RE: 16zone1039 Dorsey Lane

Case-16Zone1039-October Formal Application

Project #16Zone1039-Neighborhood Meeting-9/6/2016-7PM @Owl Creek

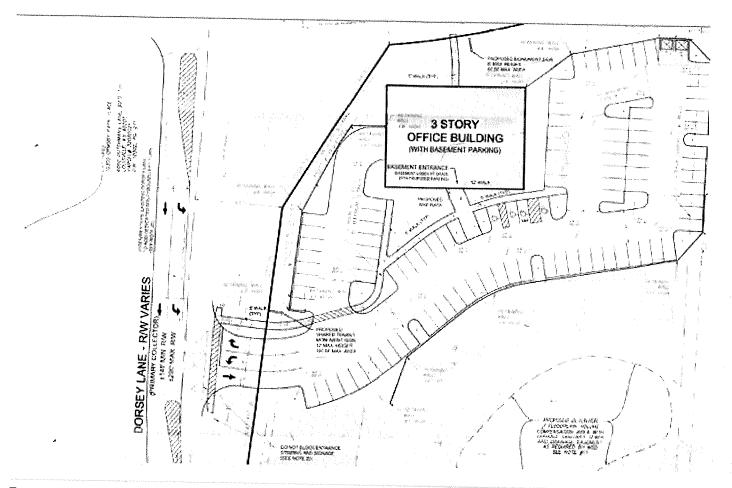
The developer has presented a plan that would widen Dorsey Lane at the intersection of Dorsey and Hurstbourne.

The widening will accommodate the left hand turn lane, the through and left lane, as well as the right turn lane heading north west.

The widening will allow for a turning lane to be located on Dorsey for drivers heading south on Dorsey to turn into the site.

This will allow for through traffic heading south to pass the site turn-in location without being delayed.

The entrance is proposed to be marked with "Do not block intersection" signs and markings.

I have reviewed and approved the plan presented to Transportation Planning with oversight from Public Works. No work is being completed in the State right of way so they have waved their review.
